2020-2143-ZC

## ZONING STAFF REPORT

Date: February 22, 2020  
Case No.: 2020-2143-ZC  
Posted: December 25, 2020

PLANNED UNIT DEVELOPMENT (PUD)  
RIVER PARK ESTATES, PHASE 3

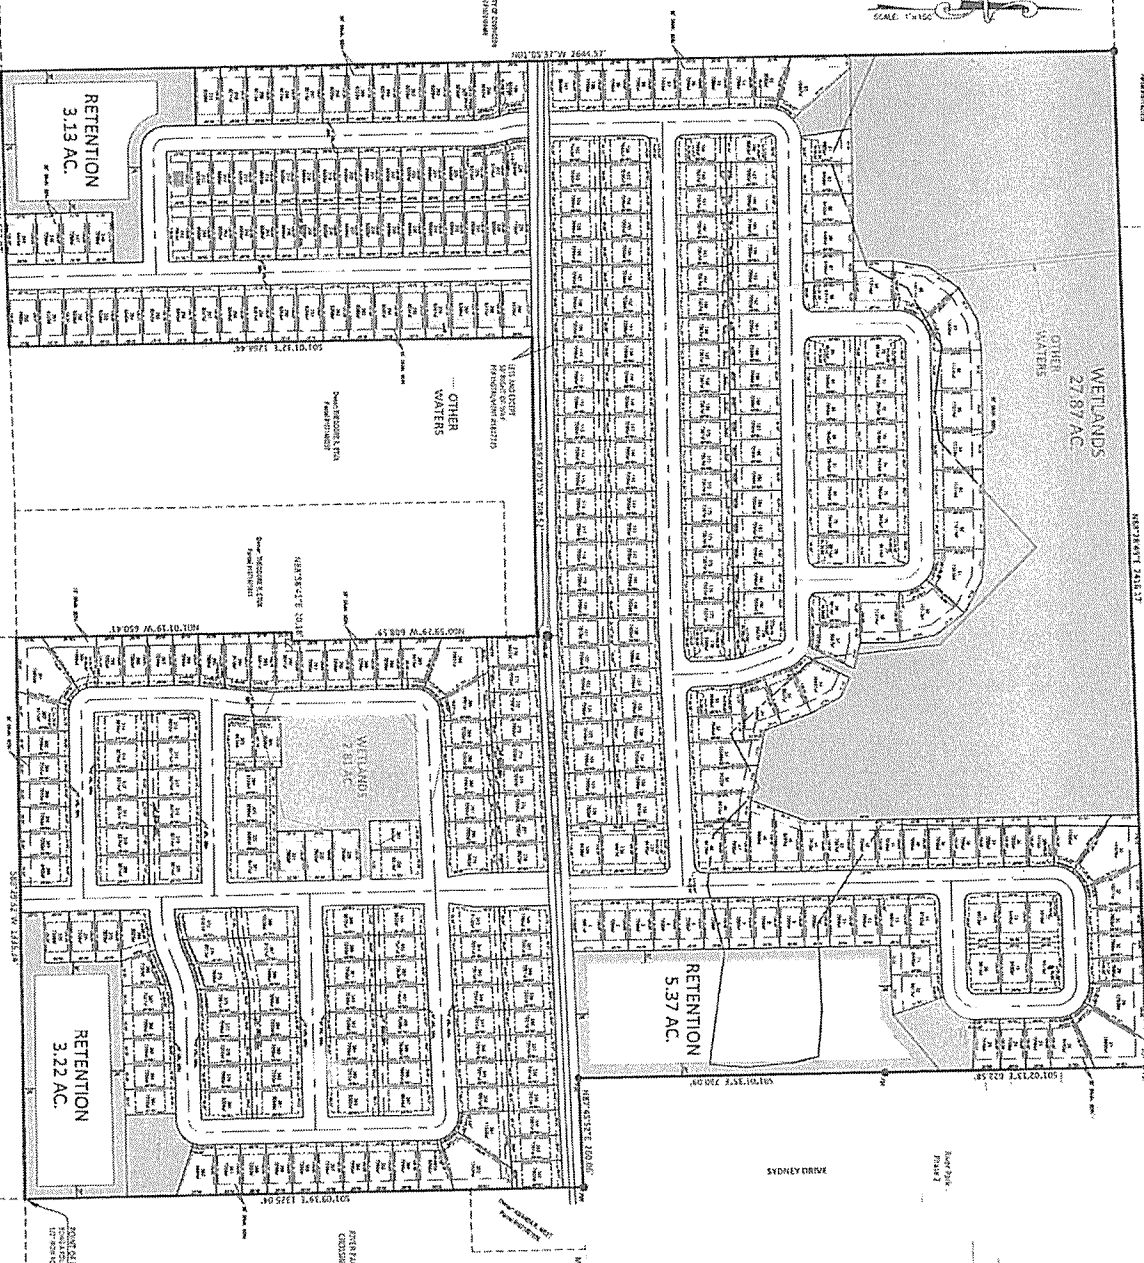
- Comments:
- a. A complete Recreational Development Plan shall be submitted depicting the proposed amenities, a time schedule for development, and the entity whom shall be responsible for the liability and maintenance of the recreational amenities and greenspace areas.

- The PUD plan shows 30.68 acres of wetlands to be maintained. Additionally, the plan is providing 11.72 acres of retention ponds.
- Informational Item: The Parish may adopt FEMA's Freeboard standard of BFE + 1 Foot by January 1, 2021. The applicant of this PUD may be required to implement the new standard after January 31, 2021.

- The proposed PUD plan provides for lots of similar size to be developed with single-family residential dwellings. The setbacks provided are uniform for all development. There is little diversification or variation of residential uses provided.
- The proposed PUD plan shows a majority of the 384 residential lots requiring a 25 ft. servitude within the entire rear yard from the building setback to the rear property line. As structures are not permitted within servitudes, this would result in no allowable fences, pools, sheds, play grounds or other typical structures found within a common backyard area.

- Almost 99% of the greenspace provided is passive in nature and is comprised of areas labeled wetlands. A total of 1.08 acres of usable open space areas labeled "basketball court" and "playground" is proposed to be provided. Considering the high density of the proposed subdivision, additional active areas and amenities should be provided.
- Per Sec. 130-1674(1)(8)(4), no more than 50% of the required open space shall be satisfied using land which is inundated by water more than four months out of the year. The applicant is proposing to use a majority of the existing wetlands to satisfy greenspace requirements. These wetlands are not programed for any form of recreation and have little formal access for the residents.

- The 5.37-acre retention pond and park area to the northeast of the proposed PUD plan aligns with an existing 3.5-acre pond and park area to the west of River Park Estates Phase 1. The existing pond that was approved in River Park Estates Phase 1 and the proposed pond for River Park Estates Phase 3 are both dedicated to be maintained by St Tammany Parish. The applicant has submitted a letter of no objection to remove the berm along either retention ponds where they connect to combine the ponds and park space with input from the Parish Engineering Office. Merging the two ponds to form a larger, semi-regional retention pond could benefit stormwater management to reduce flood risk, facilitate maintenance, and maintain higher water quality. Additionally, merging the two ponds and park space could provide greater recreational opportunities and unified access to greenspace for residents.

- The proposed traffic circulation consists of one collector type road known as M P Planche Road which provides service to River Park Estates Phases 1 and 2, and River Park Crossing Phases 1 & 2. The proposed PUD plan shows forty-seven 60-foot-wide lots fronting this main access road. Allowing home sites to have direct access on M P Planche Road will requires residents to back onto a substandard collector road that is proposed to carry an additional capacity of 384 home sites, resulting result in adverse traffic circulation for the development.

2. The proposed 3.13-acre retention pond located in the southwestern corner of the proposed PUD appears to discharge into Horse Branch near its confluence with the Upper Tchefuncte River. This waterway is currently overburdened and stormwater runoff from this proposal may require a reduction of 25% for a 100-year storm event, pre-development.

4. The proposed density for this development is above the existing density in a majority of the surrounding area. Staff has determined that the proposal for 384 homes could create negative impacts on traffic, drainage, and safety. Additionally, the lot layouts that allow traffic to back onto M P Planche Road could cause traffic issues and safety concerns.

5. The proposed drainage servitudes will interfere with the useable portion of a majority of the lot’s backyard areas.
6. The applicant has stated no objection to placing the wetlands and retention ponds into a conservation easement.

7. The applicant has stated no objection to combining the 5.37-acre retention pond and park area to the northeast of the proposed PUD with the existing 3.5-acre pond and park area to the west of River Park Estates Phase 1 with input from the Parish Engineering office.
